Chevron #9-7127; RO0000185  
10 Grant Line Rd, Tracy, CA

Tuesday, March 31, 2015  
10:00 AM

## 10 Grant Line Road Septic System Design Parameters

10 GRANTLINE RD  
 SEPTIC SCHEMATIC

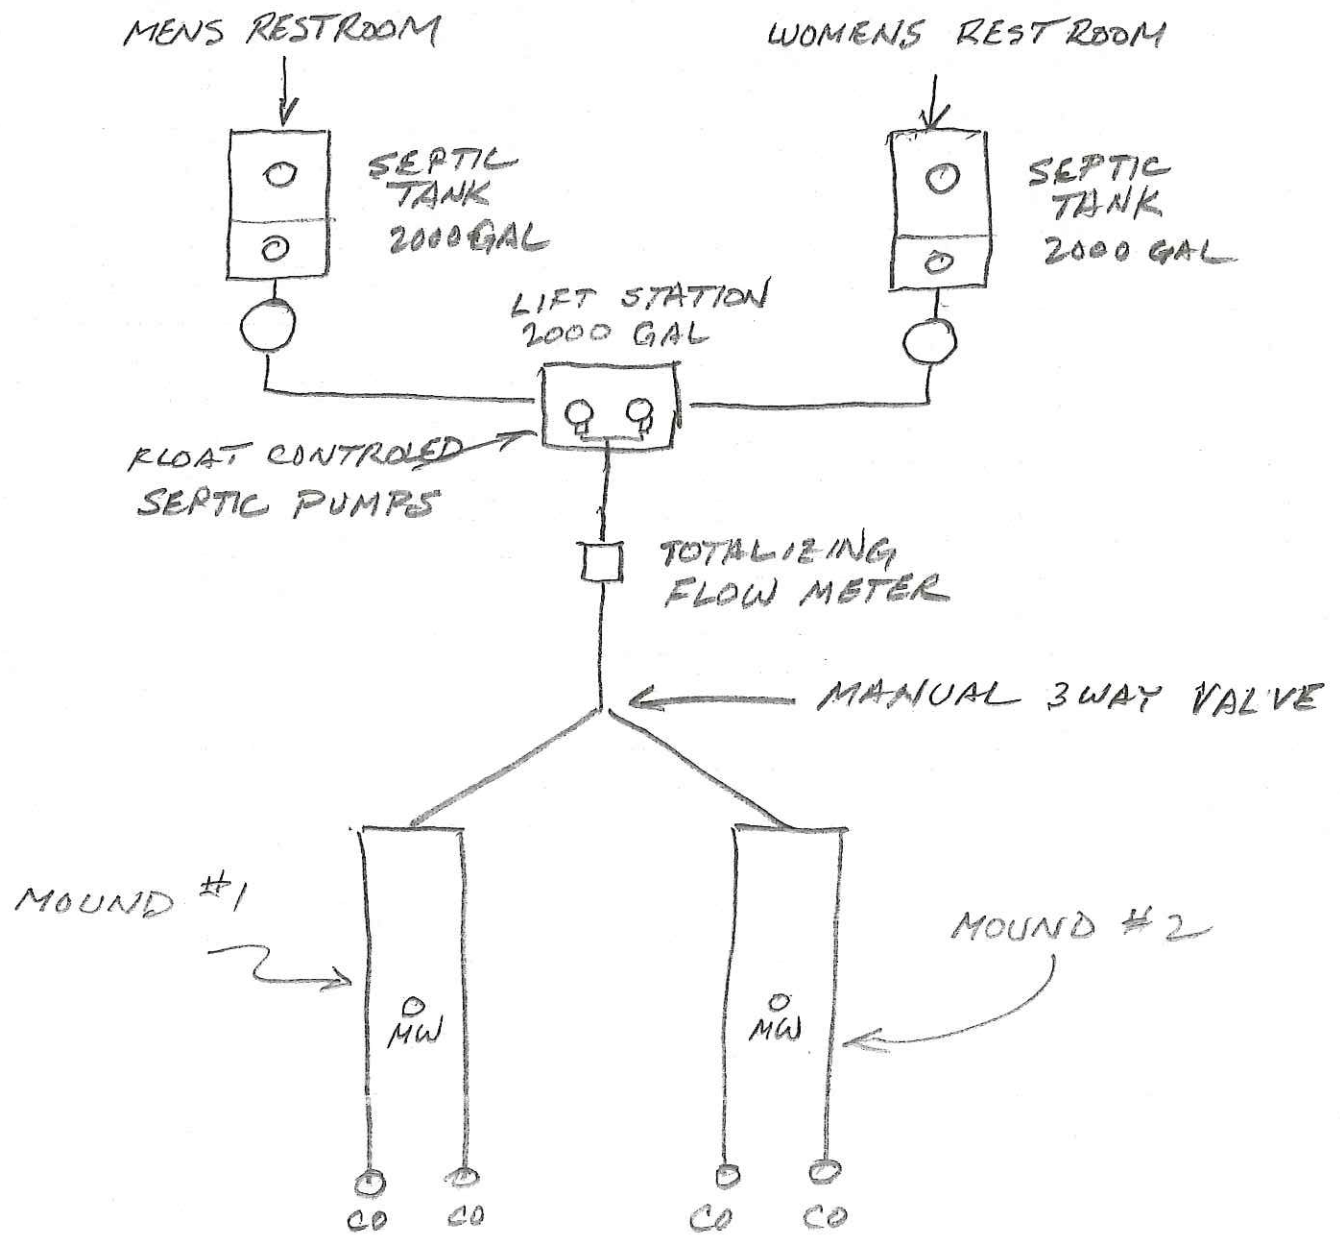
- Daily System Flow 600 – 1000 gpm. (Actual number to be determined). *hydroponics*
- 1 day surge capacity in lift station
- Septic tank effluent to be filtered and metered  
*+ Screened* *concrete not fiberglass*
- Lift station pump HP to be determined by pressure drop  
*- 2 pumps for redundancy / backup*
- Mound system to be used for effluent disposal due to shallow permeable soil on site
- Gravel width to be 10 feet *3/4"* ; workable ; no fines ; double washed
- Length depends on daily system flow (150 ft. – 250 ft.) at 4 gal/ft.

*Have 250' now; NOT a sand*

*- other options*

- downsize station
- max flow vol. helps make
- extend to N/along E. side

FIGURE  
**13**

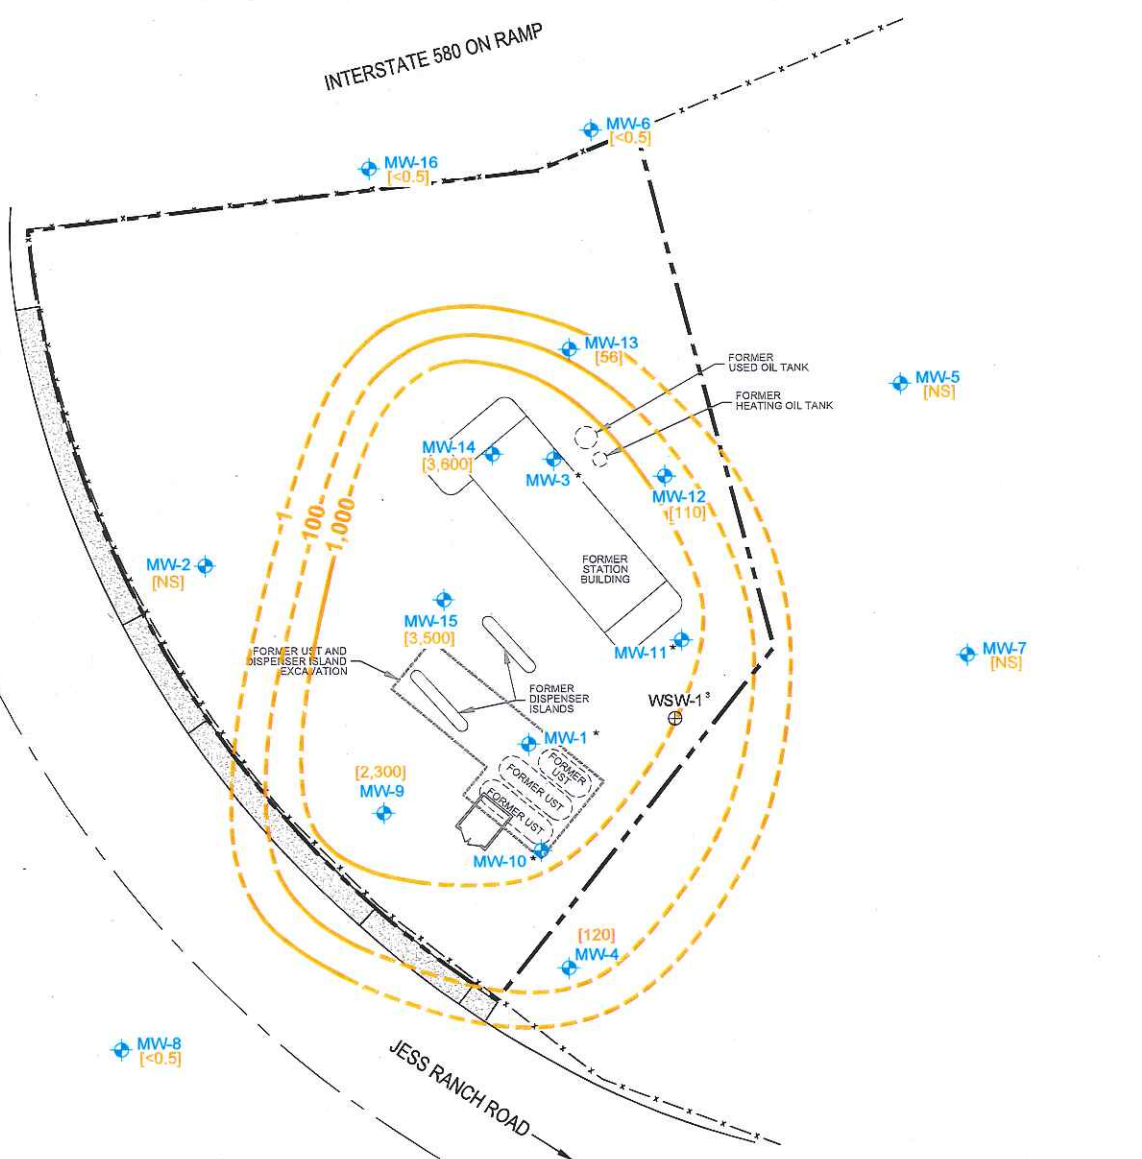
*do both @ same time*
